**RE: Project of Significant Impact (PSI) – PSI-24-01
#49 Walnut Street – Walnut Park**

We have received the design review comments dated October 8, 2025 prepared by the Assistant Town Engineer Mr. George Saraceno on behalf of the Department of Public Works, Engineering Division. We have reviewed the comments and would like to offer the following responses:

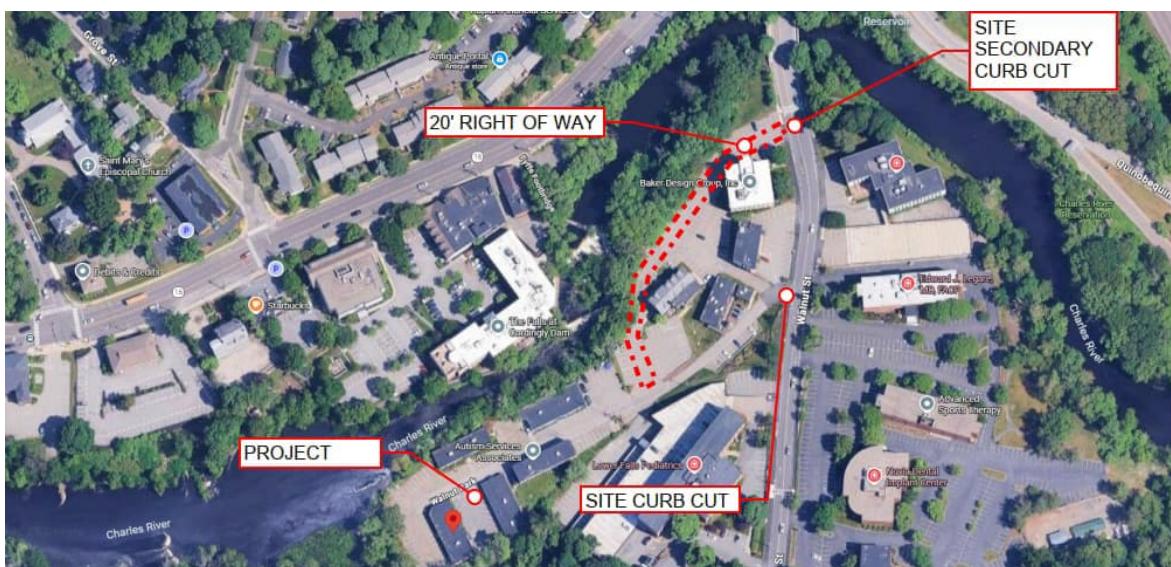
- The curb cut onto Walnut Street is substandard and has challenging sight distances. Improvements that ensure large vehicles and construction equipment can access the site without damage to the sidewalk should be made.

Response: Review of crash records does not indicate any operational or safety deficiency of the driveway including its intersection with Walnut Street, which has historically served higher generating commercial uses on the subject site. The site access/curb cut is under control of the abutting landowner that the project team has no legal right to modify it without the abutter agreement. In addition to the 15' right of way, the site is also entitled to use an existing 20' right of way to access/egress. This 20' easement has a separate curb cut on Walnut Street northerly to building # 15 where the grade is much gentler for access and better sight line for egress. We have performed a fire truck turn exhibit showing fire truck access through this secondary access and have fire department signed off on this route. See Exhibit A for Fire Truck Access Exhibit.
